# SAFETY RECALL BULLETIN

SUBJECT:			No: <b>SR-21-007REV2</b>
<b>SEAT BELT AUTOMATIC LOCKING RETRACTOR (ALR) – SAFETY RECALL CAMPAIGN - REVISION</b>			DATE: <b>November 2021</b>
			MODEL: <b>2022 Outlander</b>
<b>CIRCULATE TO:</b>	<input checked="" type="checkbox"/> GENERAL MANAGER	<input checked="" type="checkbox"/> PARTS MANAGER	<input checked="" type="checkbox"/> TECHNICIAN
<input checked="" type="checkbox"/> SERVICE ADVISOR	<input checked="" type="checkbox"/> SERVICE MANAGER	<input checked="" type="checkbox"/> WARRANTY PROCESSOR	<input checked="" type="checkbox"/> SALES MANAGER

This Safety Recall bulletin supersedes SR-21-007REV issued September 2021, to update the Repair Procedure section.

The purpose of this revision is to raise awareness to the need for extra caution when removing the locking button on the seat belt pre-tensioner connector. Please see page 11 of this recall for additional information. Revisions are italicized and indicated by:

**<<A>> SEAT BELT PRE-TENSIONER REMOVAL**

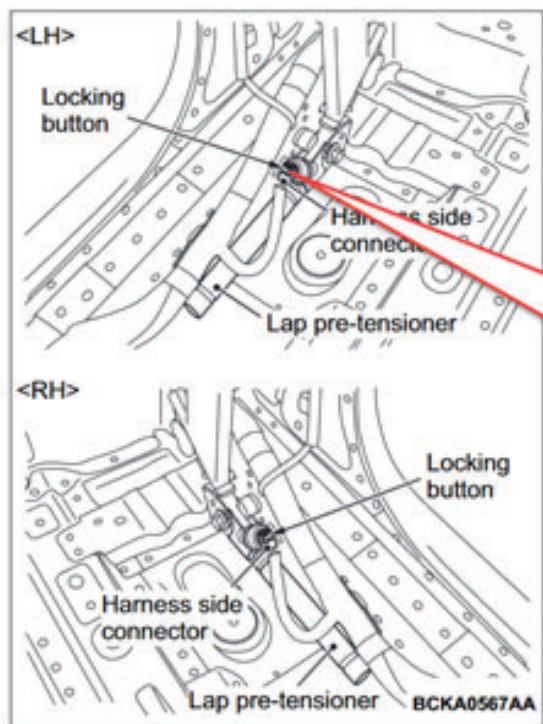
Please use **EXTRA CAUTION** when removing the locking button on the seat belt pre-tensioner connector. The locking button should only be raised approximately 1mm in an upwards direction. This will release the yellow connector body that can now be gently pulled from the pre-tensioner.

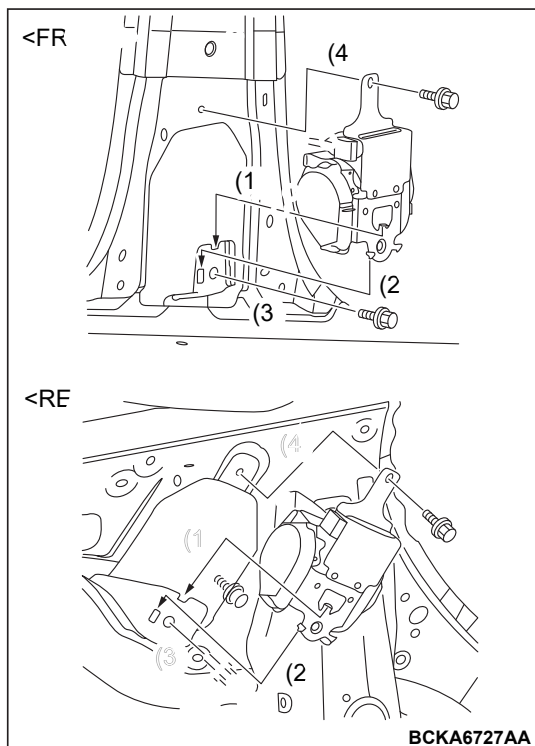
**USE EXTREME CARE TO AVOID DAMAGE** when releasing the black locking button. **DO NOT ATTEMPT TO REMOVE COMPLETELY!** The locking button is only designed to be raised approximately 1mm which permits removal of the connector.
